Subject: Response to FINAL- U.S. EPR Design Certification Application RAI No. 566 (6955), FSAR Ch. 6, Question 06.02.05-32 - Supplement 2
Sent Date: 11/19/2013 11:40:53 PM
Received Date: 11/19/2013 11:46:02 PM
From: HOTTLE Nathan (AREVA)

U.S. EPR Standard Design Certification

SRP Section: 06.02.05 - Combustible Gas Control in Containment

Question 06.02.05-32:

Figure 06.02.05-32-1—Volume of Hydrogen from Zirconium

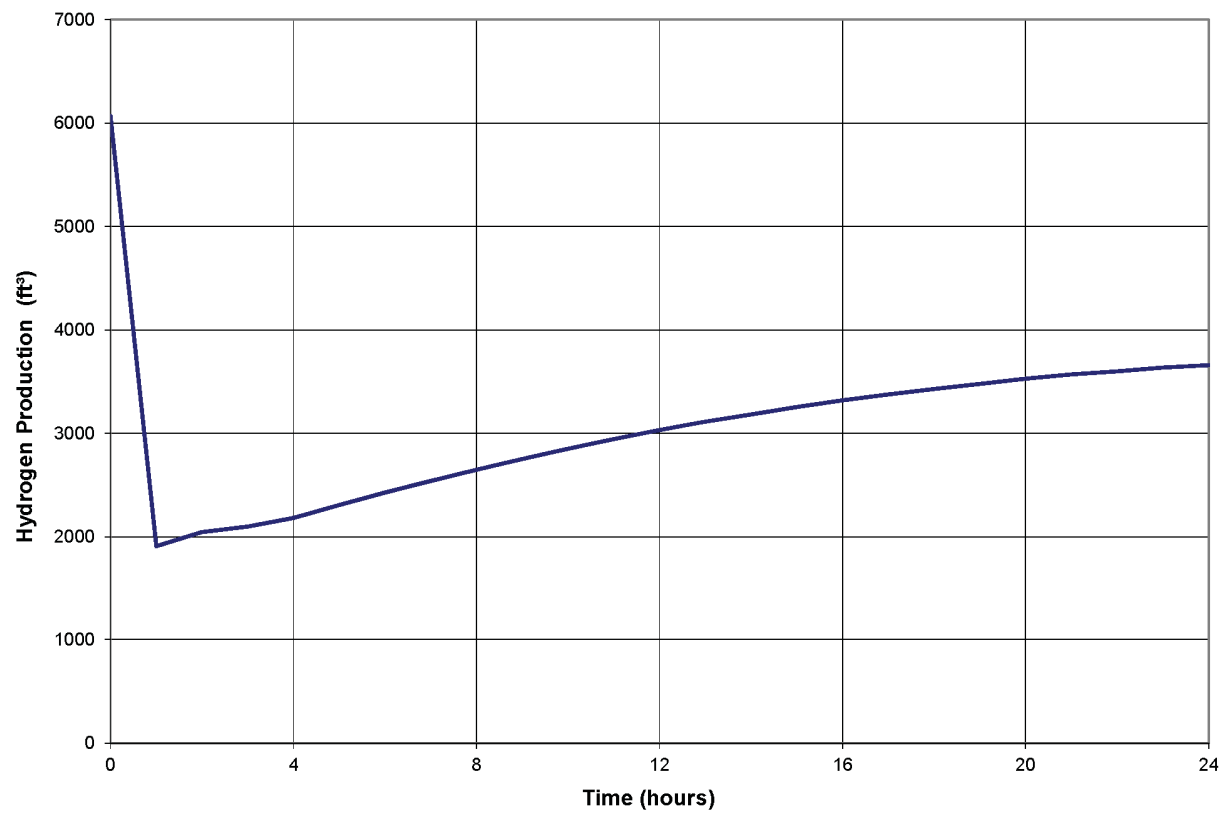
The confirmatory evaluation of U.S. EPR™ CGCS performance under design basis accident conditions was carried out using the MELCOR code, with input based on the recent AREVA model. The comparison of MELCOR and AREVA results showed that the MELCOR predicted containment hydrogen concentration is approximately 45% to 73% higher than the AREVA prediction for the design basis scenario in which PARs are not credited, and exceeds 4 %.

Volumetric rates of these sources are provided in the FSAR, where adequate information on the pressures and temperatures at which these sources are calculated is not. Furthermore, the locations or distribution of these sources in the MAAP calculations are not known. For example, it is not clear whether the 1% core oxidation source was added to the RCS or directly into the containment volumes. Therefore, please provide, for each hydrogen source, the following:

It is assumed that 1% of the zirconium in the core oxidizes. This is conservative as it is the limit allowed for a DBA. The total mass of hydrogen generated from zirconium is calculated and remains present in the same quantity throughout the accident. However, the volume of hydrogen generated from zirconium varies based on the accident pressure and temperature profile. The mass of hydrogen produced from zirconium oxidation is calculated to be 33.3 lbm. Based on a containment pressure and temperature at the end of 24 hours of 32.5 psia and 210°F, respectively, the volume is calculated to be 3,660 ft³. The volume of hydrogen present in the containment from zirconium oxidation over time is provided in Figure 06.05.02-32-1.

The source of hydrogen from zirconium is in the core which will be transferred through the break in the lower equipment area. The oxidation is assumed to happen immediately in the initiation of the accident. The flow out the break will therefore follow the steam path up through the top of the equipment areas and accumulate in the dome.

Figure 06.02.05-32-6—Flow Patterns in Containment during LOCA Blowdown

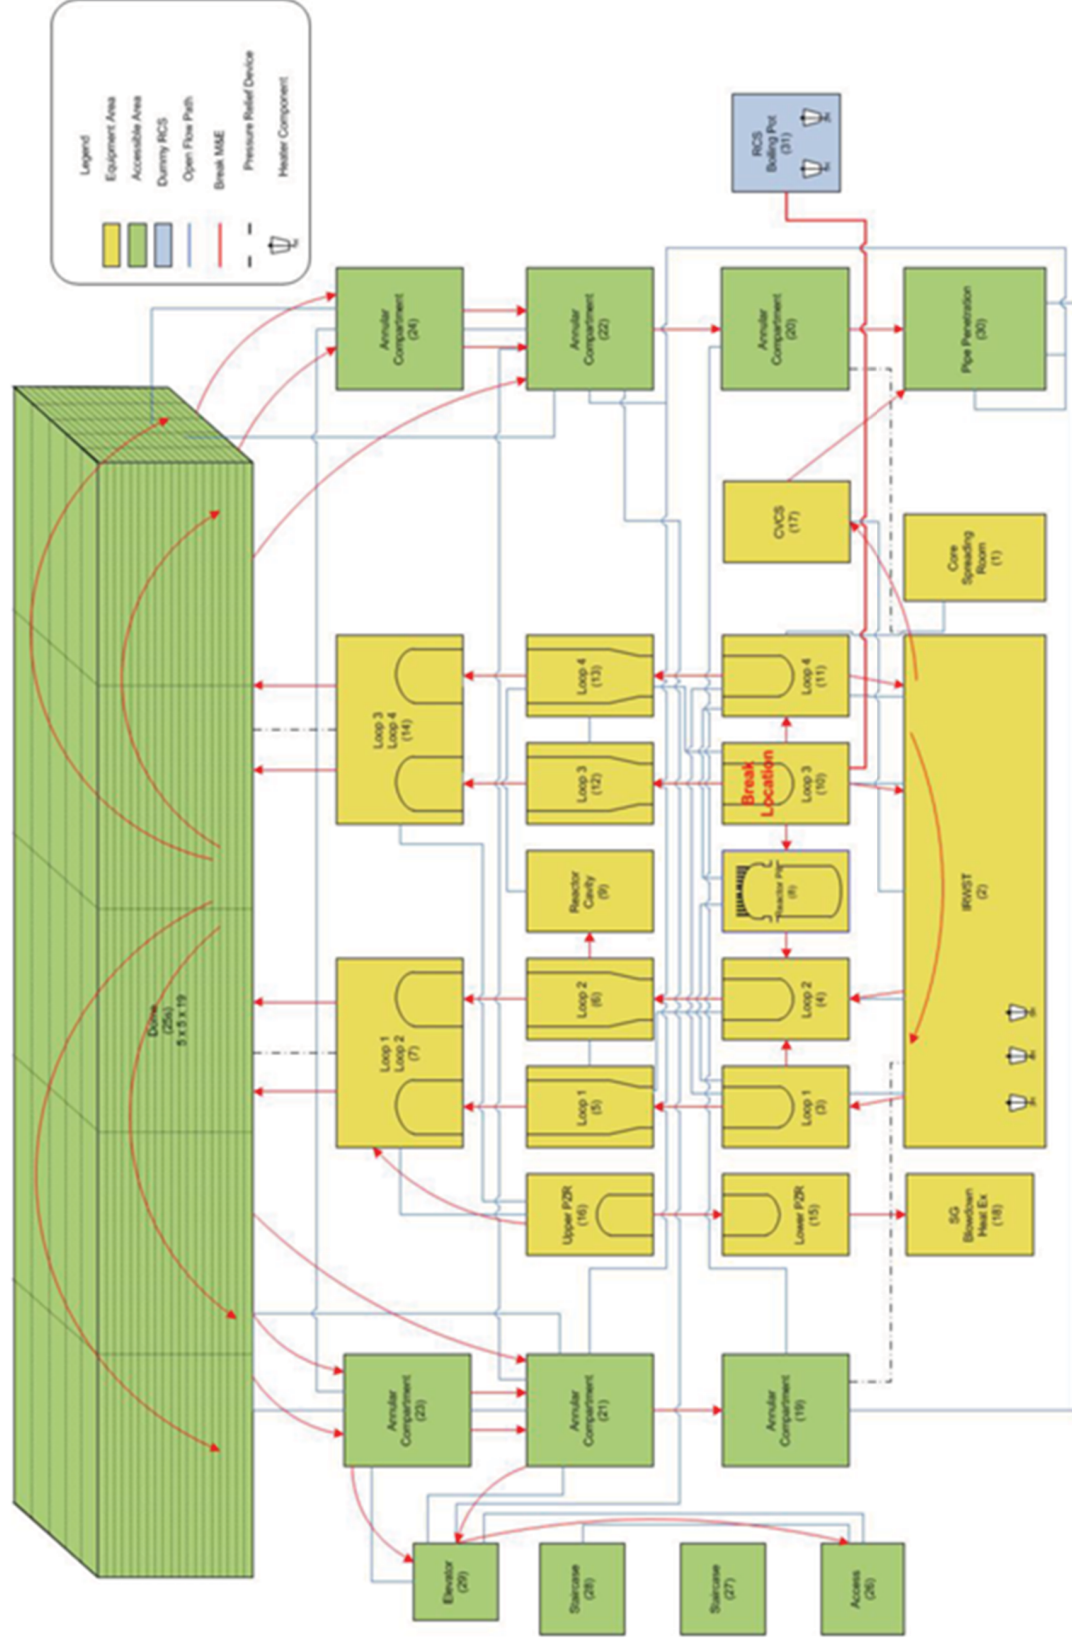
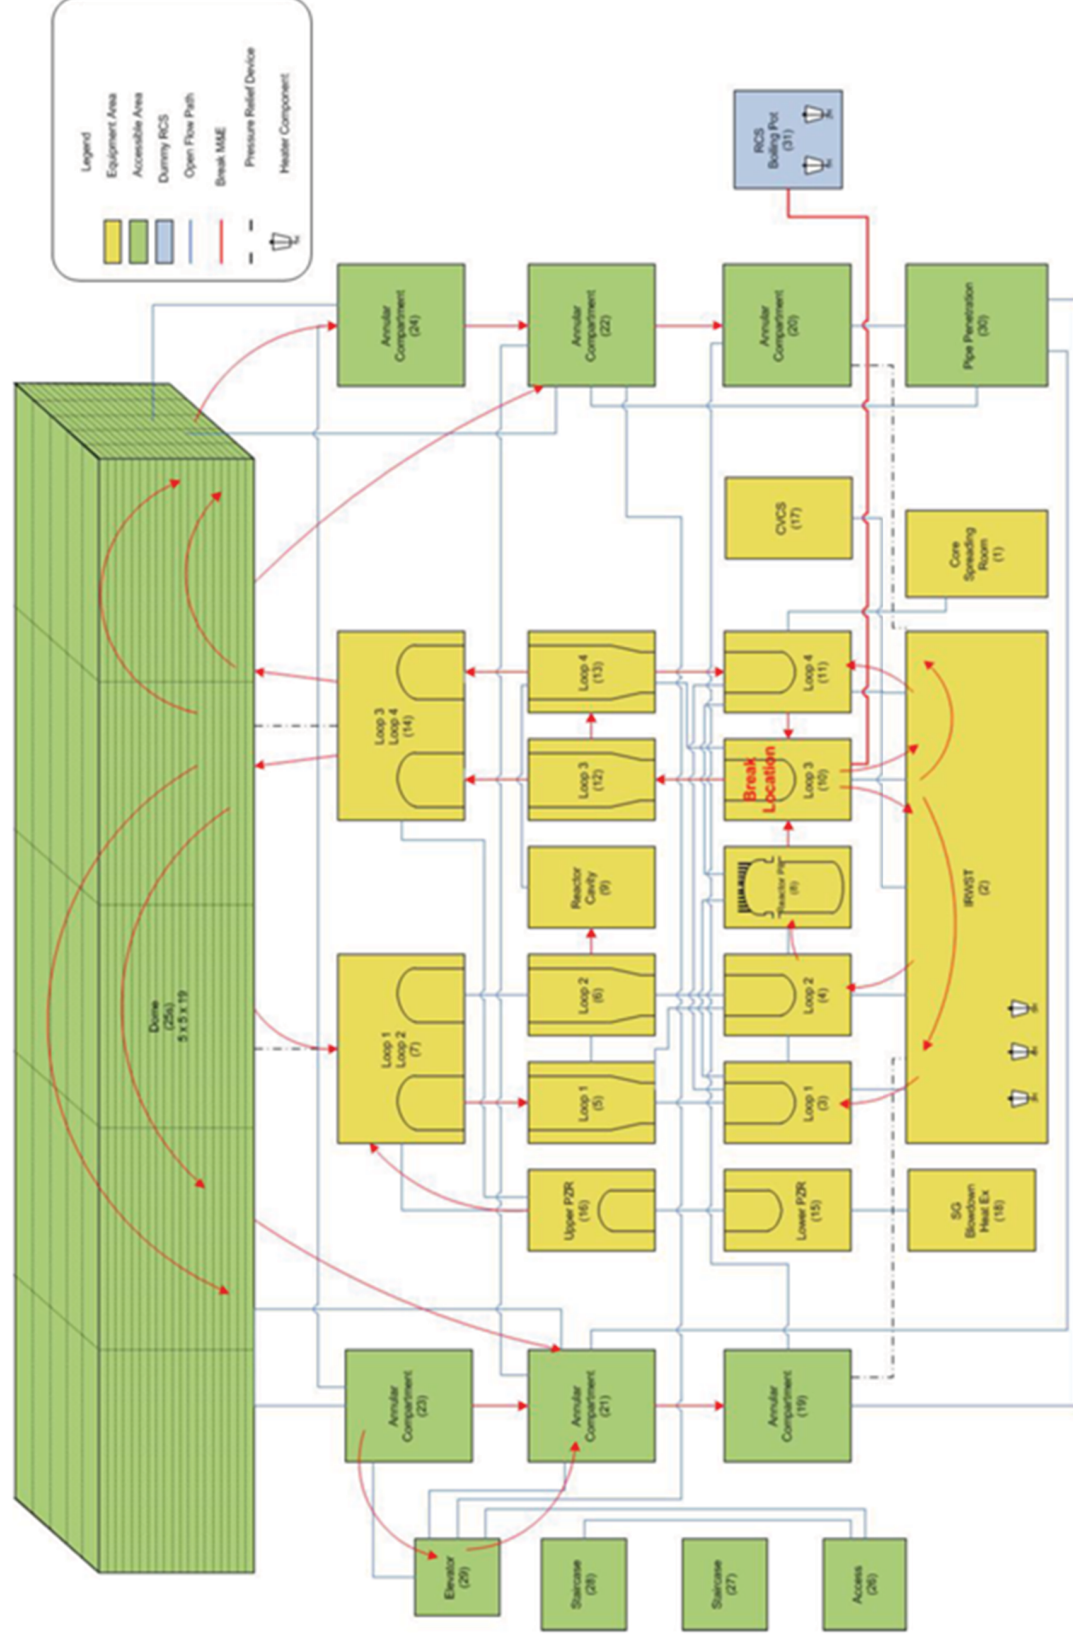
Location or distribution of source in AREVA model computational nodes

The five sources of hydrogen considered in this analysis are well distributed throughout the containment building to begin with. Hydrogen generated from zirconium oxidation and radiolysis will be deposited out the break and follow steam flow up through the equipment areas and into the dome. Hydrogen generated from zinc-based paint and galvanized steel is will distributed through the equipment areas and dome. Aluminum allocation is primarily restricted to the IRWST and polar crane. The steam flow patterns during the accident transient will move upwards through the equipment areas, accumulate in the dome, and down through the annular regions. The highest flow rates occur at the very beginning of the accident, also when a majority of the hydrogen is produced. Much of the hydrogen generated at this time will be accumulated in the dome. The blowdown flow patterns are visually represented in a nodal diagram provided in Figure 06.02.05-32-6. Later in the accident, there is very little flow across containment, and also less hydrogen is being produced. The flow patterns that still circulate later in the transient are shown in Figure 06.02.05-32-7. Only velocities greater than 1 ft/s between control volumes are represented with arrows in this diagram.
